STATE OF MARYLAND WELL COMPLETION REPORT

HOWARD COUNTY HEALTH DEPARTMENT

RE: King's Gift, Lot #42
11716 Frederick Road
Well Permit #HO-81-1968

LOT 41C Now
Lot 42
116191
RH

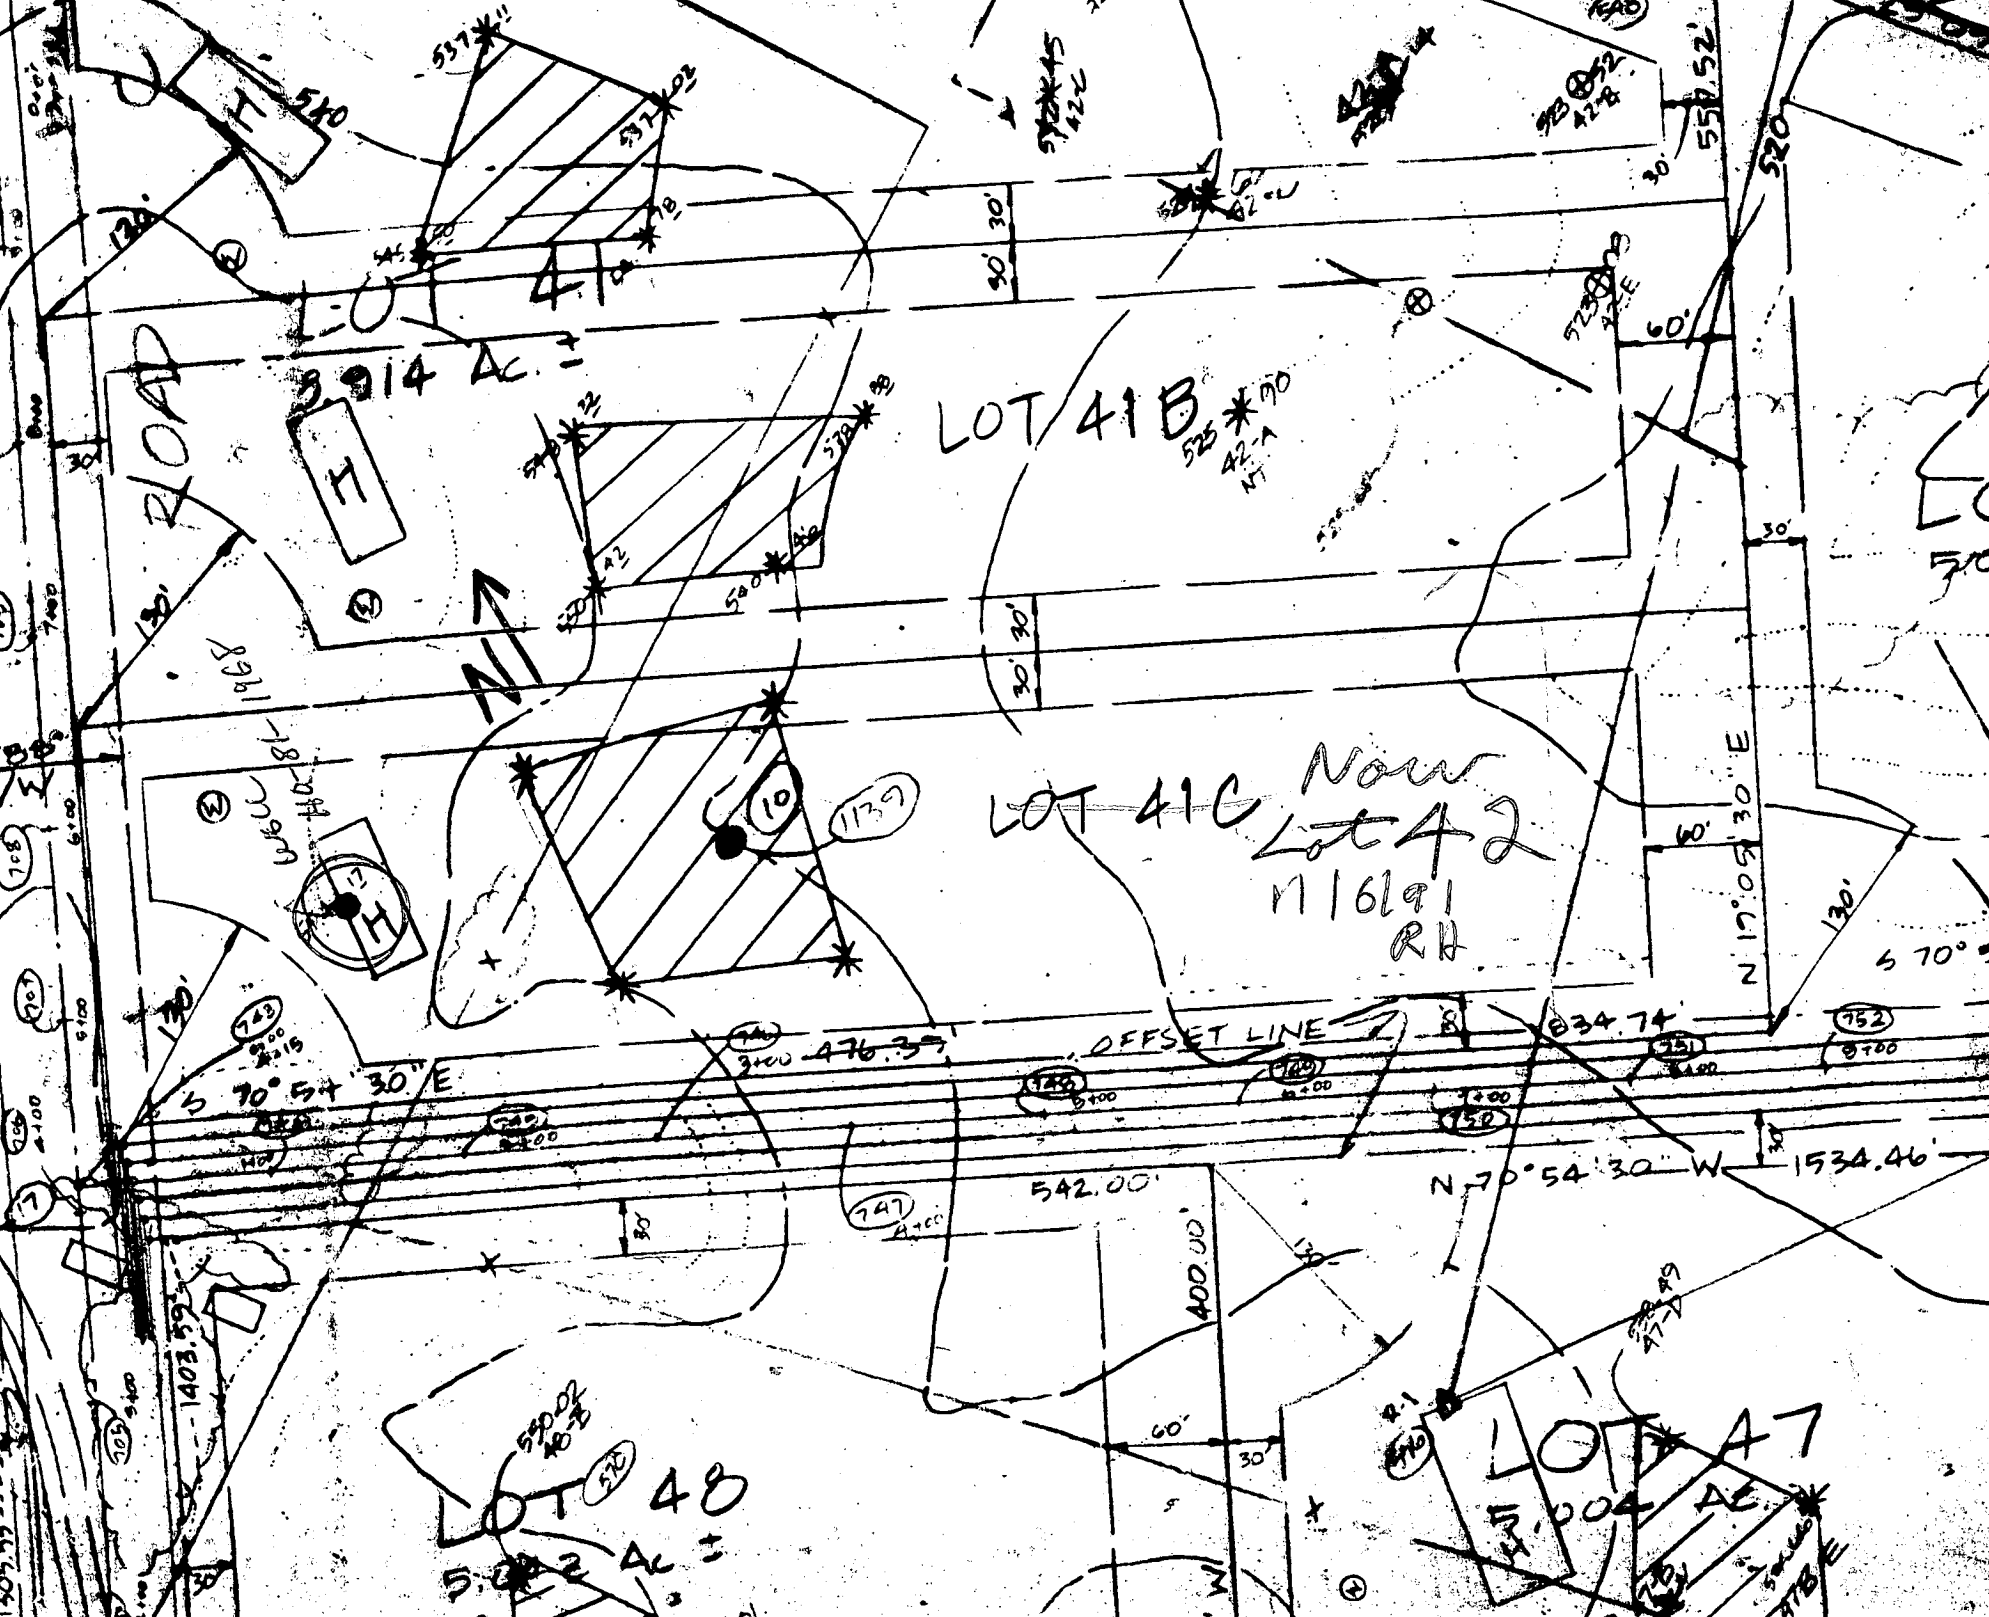
This is to advise you that during the septic system installation inspection for the above referenced property, a sanitarian from this office observed that the well casing for the well installed under permit #HO-81-1968 terminated below ground level. According to COMAR 26.04.04.07, "A minimum of 8 inches of the casing length shall extend above ground level after final grading."

Until this problem is resolved, an Interim Certificate-of-Potability will not be issued for this property. Please contact this office as soon as this problem is corrected so that an inspection can be made.
